**DEPARTMENT OF COMMUNITY DEVELOPMENT SERVICES**

**DATE:** December 4, 2008

**SUBJECT:** DRB-2008-02: A request by Andrew Fell to review the site plan and design of 605 W. Green Street in the MOR, Mixed Office Residential Zoning District.

PROPOSED SITE PLAN  
 SCALE: 1" = 20'-0"

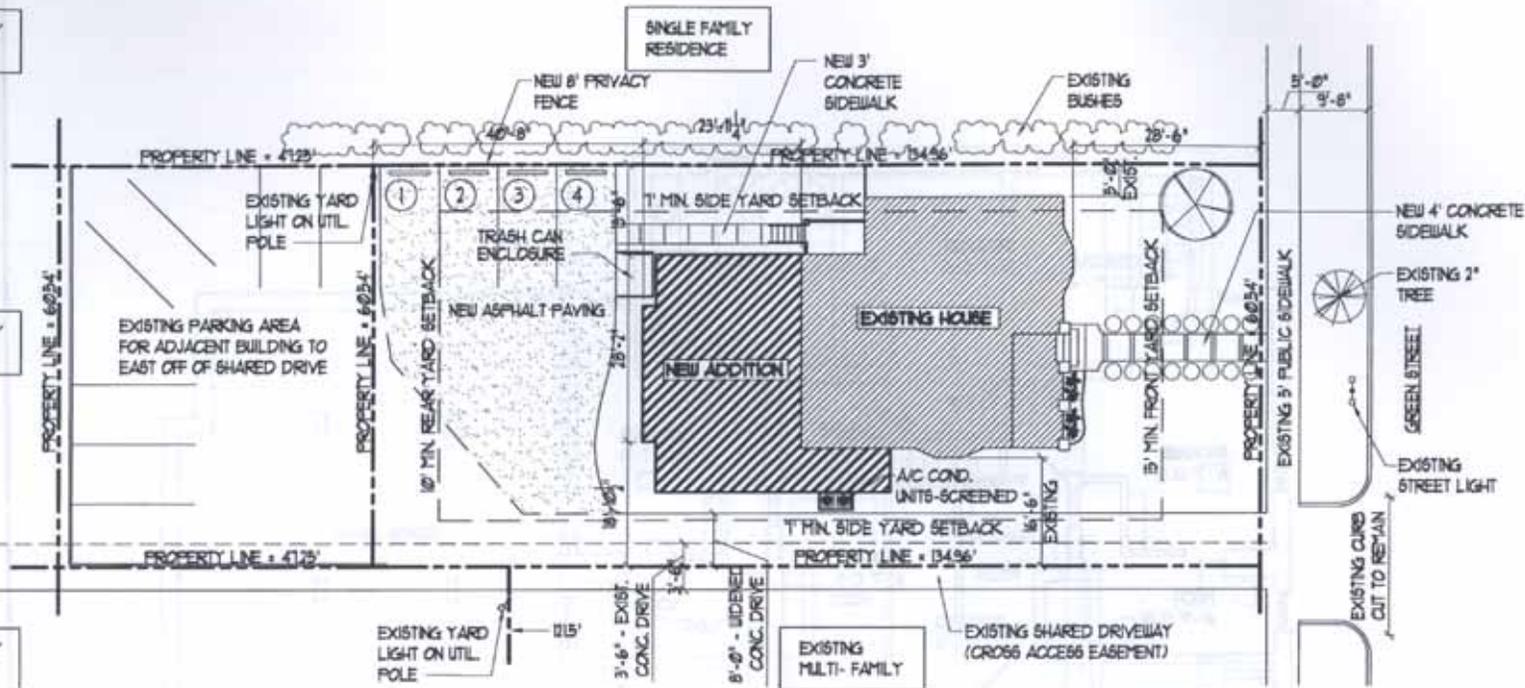
The subject property has four parking spaces to the rear of the existing house. The parking area is existing and the proposal will not change the layout of the parking area. The proposal does include paving the parking area which is currently gravel. The applicant will work with the City Engineer regarding the paving, to ensure the paving does not cause any drainage issues and is an approved dust-resistant paving material. The proposal also includes the installation of an eight-foot privacy fence to screen the parking area from the adjacent property to the west.

*The existing parking area is located behind the building and would remain as is. The petitioner proposes paving the parking area, currently gravel, with new asphalt paving, which would be an improvement. The proposal additionally calls for the installation of a new eight-foot privacy fence to better screen the parking area from the adjacent property. The petitioner has stated that*

*the fence would be a PVC fence, similar to the fence at Coler Crossing, 701 W. Green Street, in the MOR zoning district. The proposal also includes the additional improvement of widening the existing seven-foot driveway, which is shared with the property to the east. The improved driveway would be 11.5 feet wide.*

*The parking lot and driveway are existing. The proposal includes a new eight-foot privacy fence to screen the parking area from the single-family residence to the west. The petitioner has indicated that the fence will be PVC-clad. The proposal would not change the parking area, but would include paving the area that is now gravel. The existing driveway is a shared driveway*

*with the apartment building to the east. The driveway would be widened, from seven feet to 11.5 feet. This would be an improvement over the existing driveway. The south side of the parking area would not need to be screened. The parking area would be located behind the structure, as is compatible with the pattern of the neighborhood. City staff recommends that the MOR DRB find that the proposal meets the design guidelines for Parking Areas.*

1. Cement fiberboard (Hardiplank or similar) be used where the plans show horizontal board siding and shingles.
2. The decorative roof brackets supporting the gable on the (second floor of the) front façade remain.
